BCA & Accessibility Assessment Report

Multi-Level Industrial Unit Development
14 Aquatic Drive, Frenchs Forest

Goodman

18 March 2025

Fig. 6 – Level 1 Exposure to side boundary

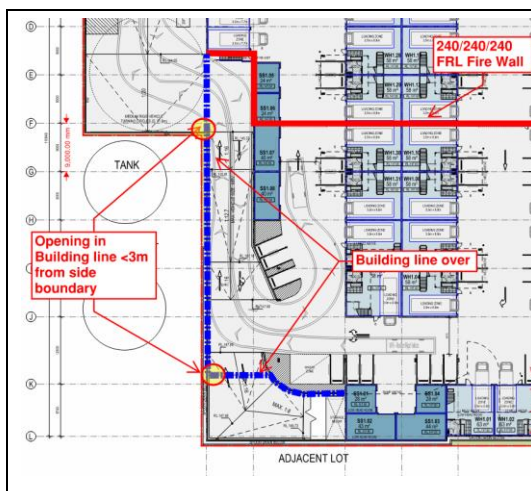
Comment: A fire engineered performance solution is required to allow the openings on the southern vehicle ramps leading from Level 1 up into Level 2 to not be protected when they are located within 3m of the side boundary. See below exposure areas marked in Figure 6 & 7.

Fig. 9 – Level 1 Horizontal Exits

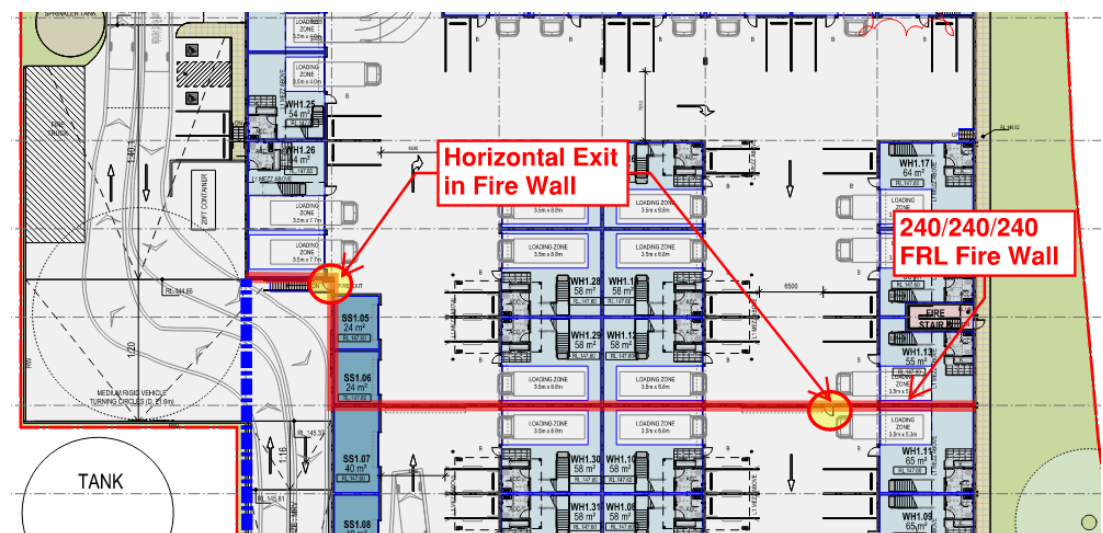
Comment: The two doors in the fire wall dividing the Level 1 fire compartments are considered to form a horizontal exit for each compartment. The horizontal exit on the northern side has been assessed as serving the western fire compartment and the door on the southern side serving the eastern fire compartment – see diagram below.

Fig. 10 – Ground Level Main Entry Door Circulation Space at top of ramp

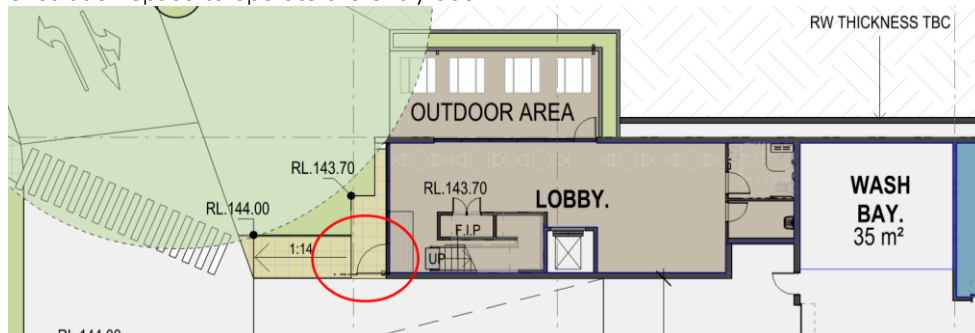
- + Every common area and entry ramp must be constructed in accordance with Clause 10.3 of AS 1428.1-2009, except if they serve the areas in the building that a D4D5 Exemption has been applied to or are located in fire isolated exits. Details will need to be confirmed on the CC Application plans.
- + The design of the landing at the main Ground Floor Lobby entry does not provide for both a compliant landing with handrails at the top of the ramp that takes into consideration the required circulation space to operate the entry door.
